Value Engineering Study

KY338 RECONSTRUCTION PROJECT AT I-71/I-75 BOONE COUNTY, KENTUCKY

VE STUDY NUMBER 201206

Draft Report

VALUE ENGINEERING RECOMMENDATION # VE-11
SKETCH OF RECOMMENDED DESIGN

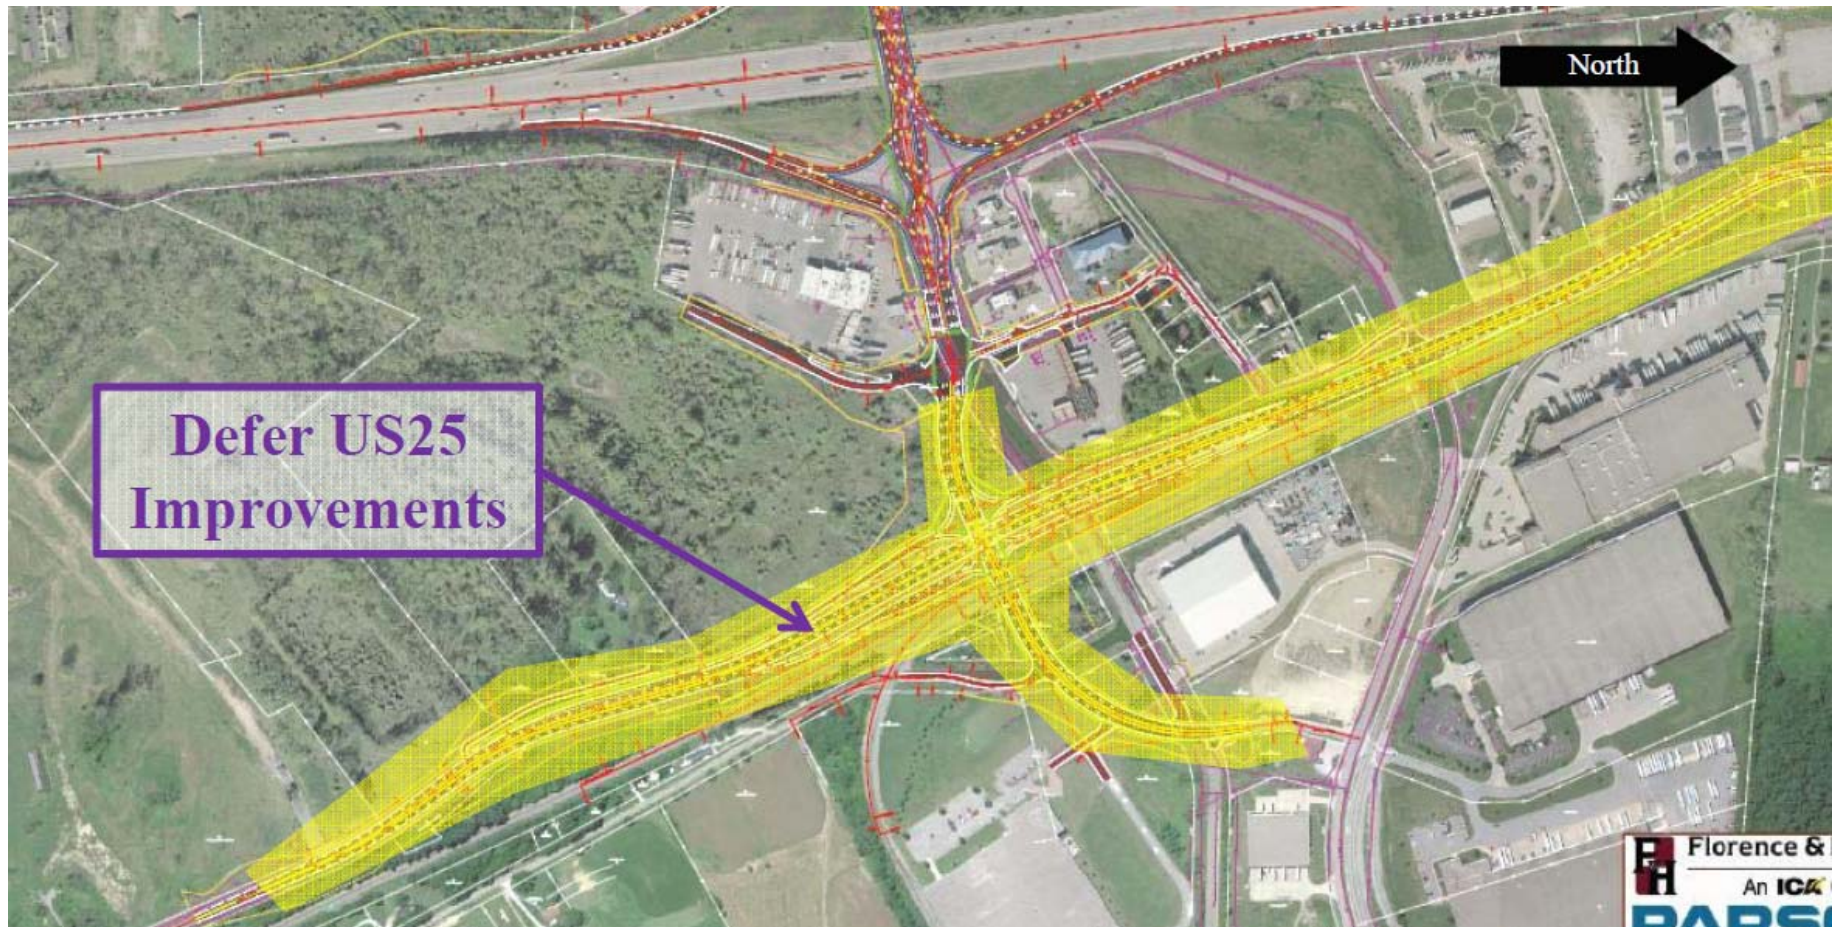
While it is understood that US25 improvements have their own set of benefits, funding for the complete project might not be available for a very long time. Breaking the project into parts would allow more urgent portion(s) to be constructed sooner.

VALUE ENGINEERING RECOMMENDATION # VE-12

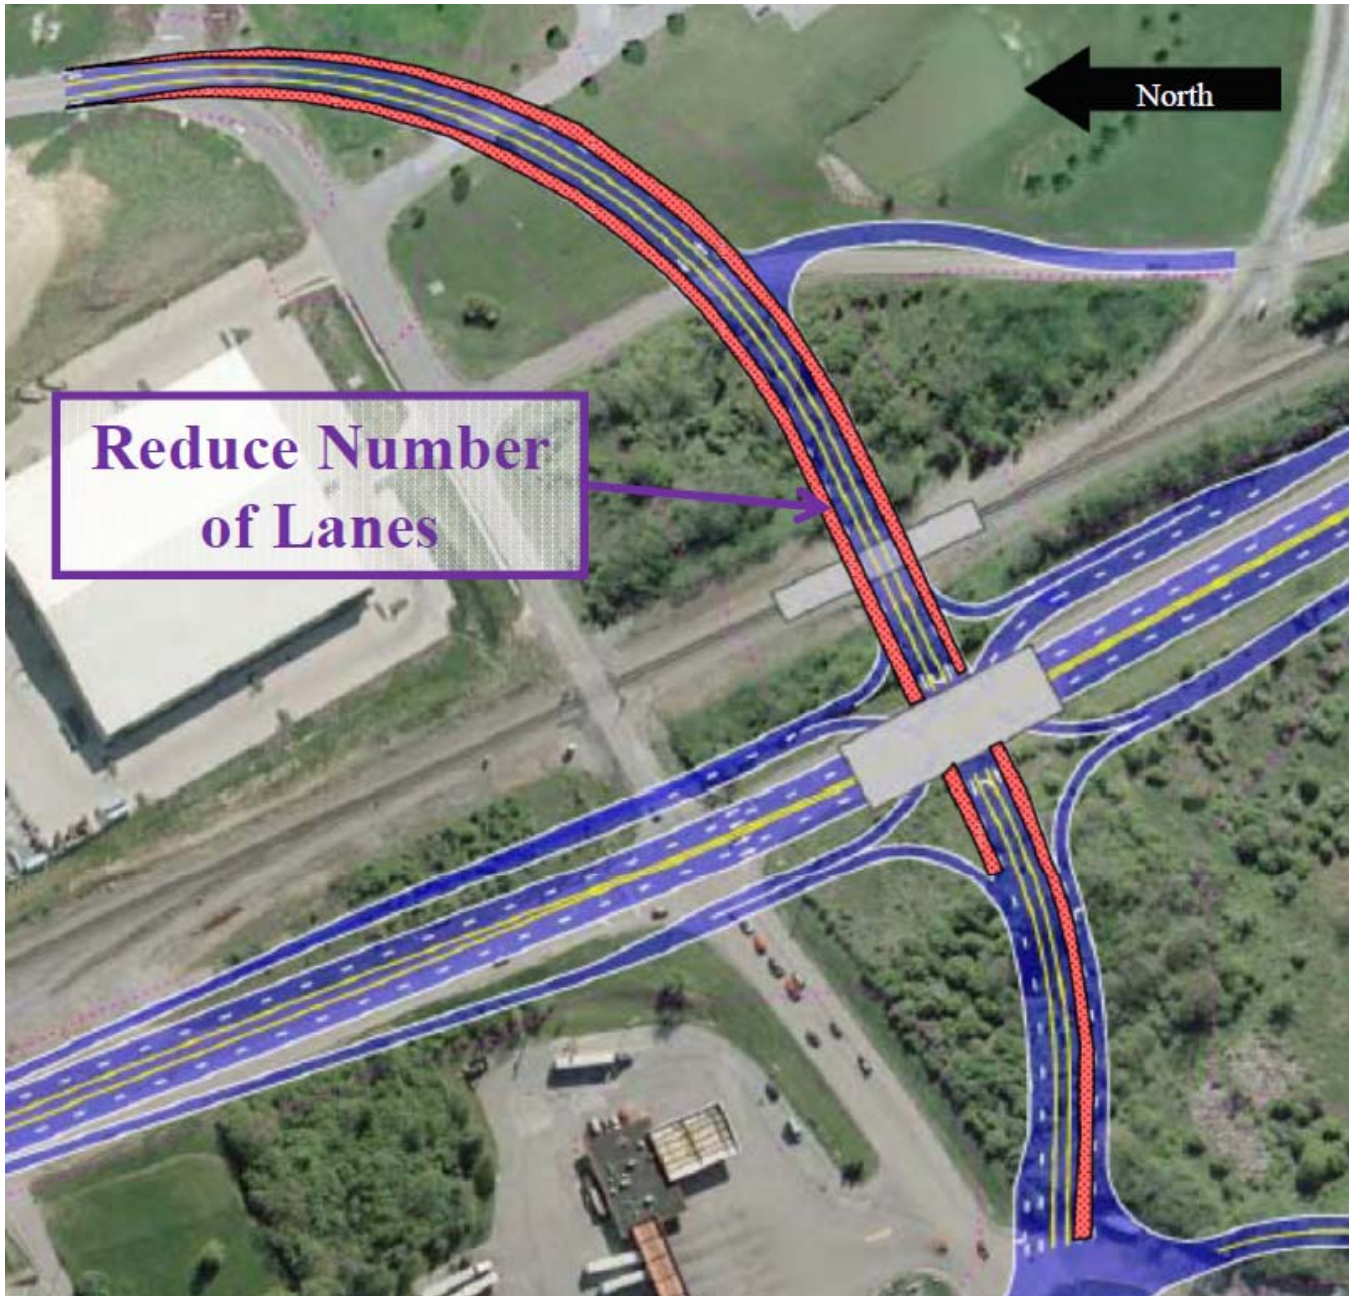
The recommended change of reducing the number of lanes on KY338 east of Best Pal Drive provides adequate vehicular capacity in the proposed design year.

VALUE ENGINEERING DESIGN COMMENT # VE-13

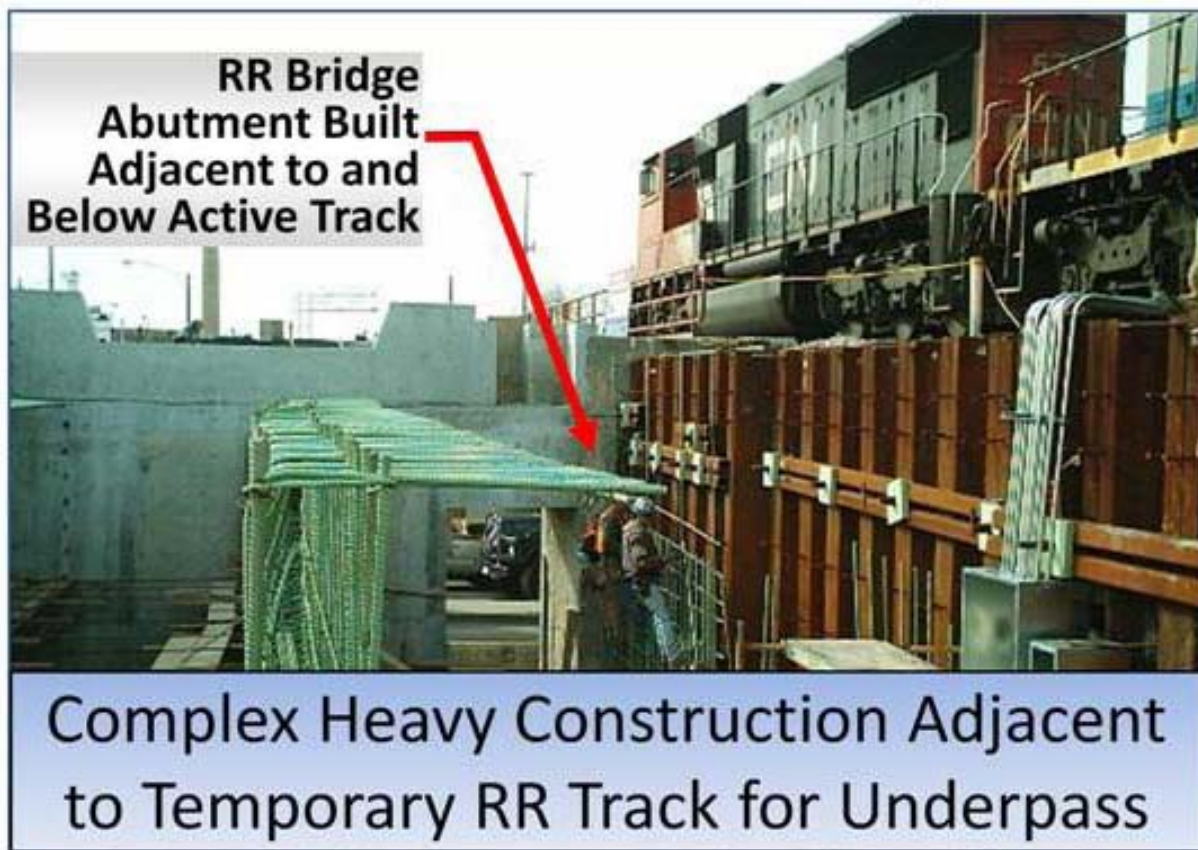
Investigate top-down construction of the railroad bridge overpass to eliminate the need for temporary retaining walls.

Construction of the grade separation at KY338 and the NS railroad will subsequently require construction of a detour track to maintain rail traffic. Grade separation at this intersection involves constructing a cut to allow KY338 under the railroad while maintaining the adjacent rail profile. A tied back sheet pile wall is a common solution to achieve the required grade separation (see figure below). The VE Team recommends investigating a “top down” construction solution to that would eliminate use of the sheet pile wall.

When rail traffic is shifted back to the permanent alignment and the temporary track is removed, final excavation can take place to the proposed KY338 grade. This construction method could eliminate the need for a costly sheet pile wall to support heavy rail traffic on the NS Railroad.

VALUE ENGINEERING RECOMMENDATION # VE-14

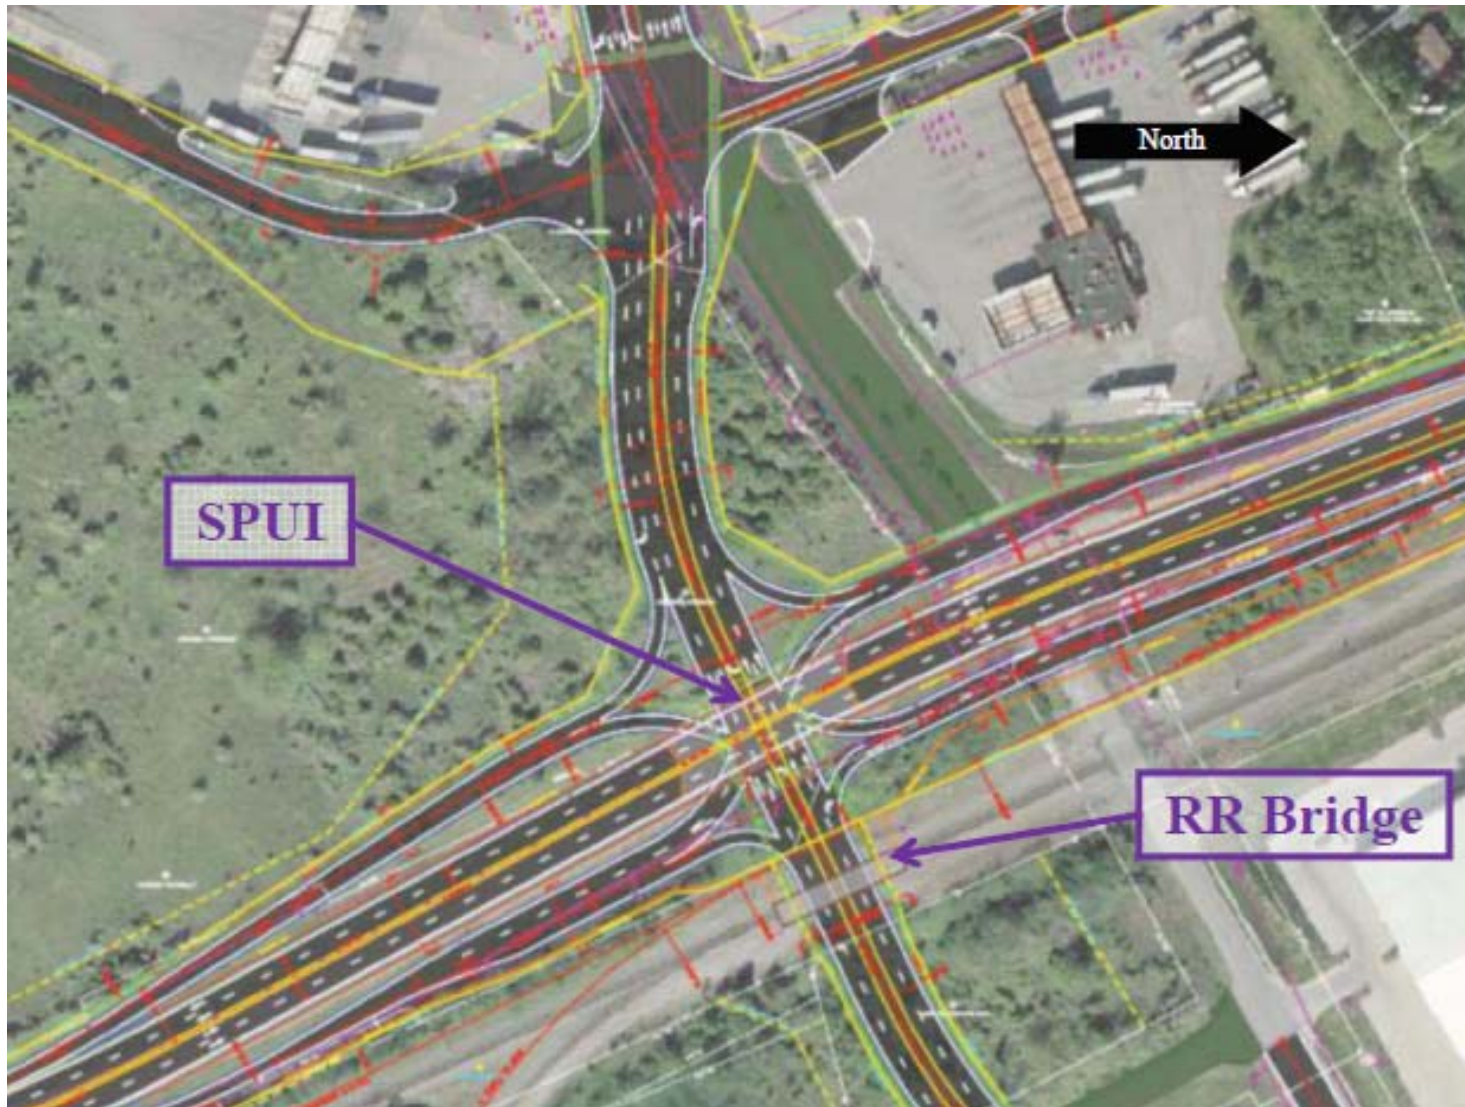
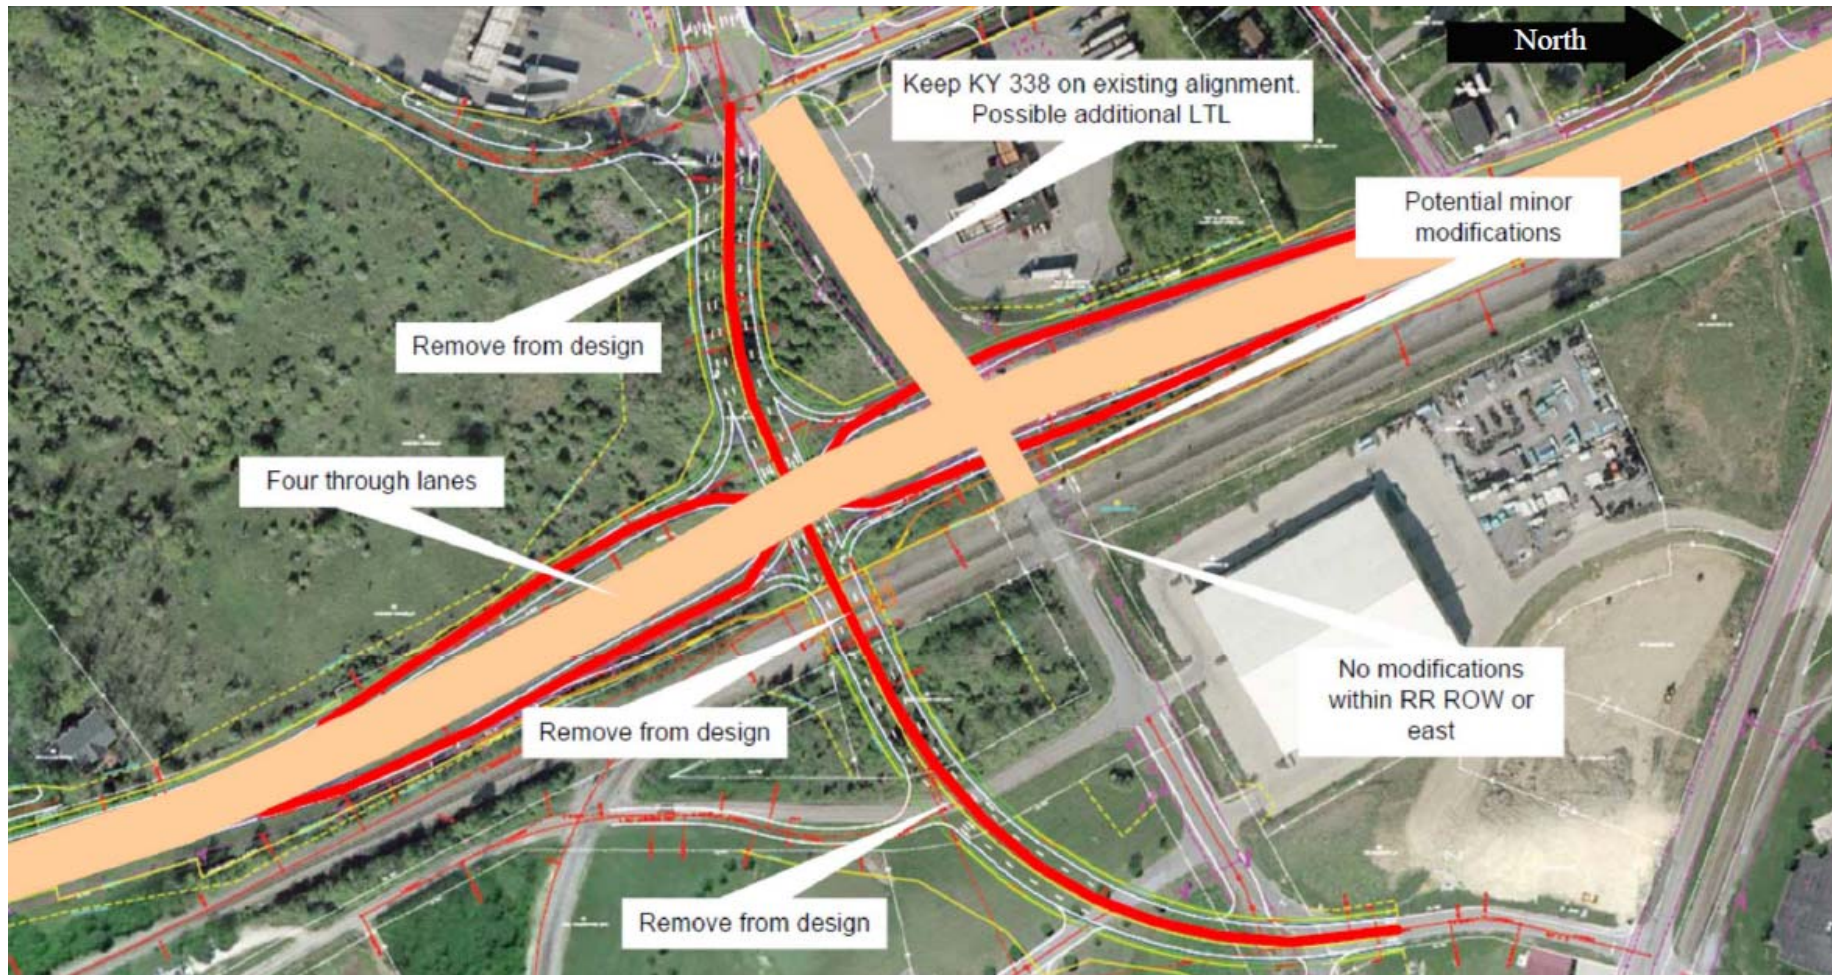
The VE Team recommends that improved KY338 have an at-grade intersection with improved US25 at the same elevation as the track and meet existing two-lane KY338 at the existing Norfolk Southern grade crossing. This recommendation would eliminate the SPUI & railroad structures and walls, eliminate interchange ramps, eliminate maintenance of rail traffic, and eliminate work in the industrial park. Access roads at Best Pal Drive northward and TSA southward would be included. The plan view would appear more as Alternative E-3 than Alternative E-1.
